PROPOSED ACCESS TO 42 ARTHUR HIGHWAY, DUNALLEY

Development Application: Response to Request for Information 16-42 Arthur Highway, Dunalley 7.2022.5.1 30/08/2022 Plans Reference: P4

This TIA seeks to address the relevant clauses within Code E5.0 Road and Railway Asset Code and E6.0 Parking and Access Code of the Sorell Interim Planning Scheme, 2015 as well as the RFI received from Sorell Council.

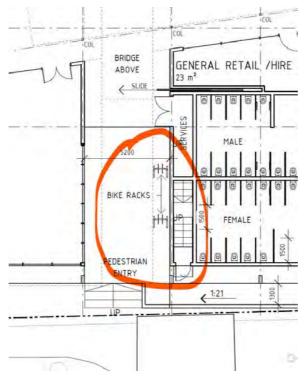
6. Provide an updated site plan showing the required motorcycle spaces, Council would potentially agree to a reduced landscaping area to facilitate these spaces.

A response to this request is being prepared.

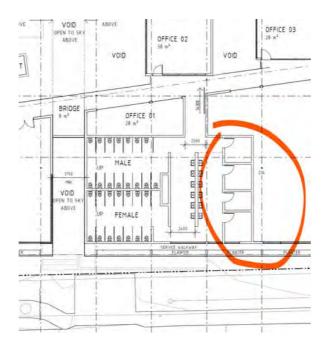
7. Show the location of the bicycle parking and end trip facilities on the site plan.

Bike racks shown on the proposed ground floor plan. There will be at least 6 employee (Class 2) spaces within a locked compound with a communal key located within the screened alcove at the eastern end of the building.

Other bike racks (more than the required 3) for visitors are noted on the Ground Floor Plan within the central pedestrian entry space.

The end of trip facilities including 2 x showers and change room facilities will be provided within one or two of the rooms adjacent to the central amenities area on the Level 1 Floor Plan.
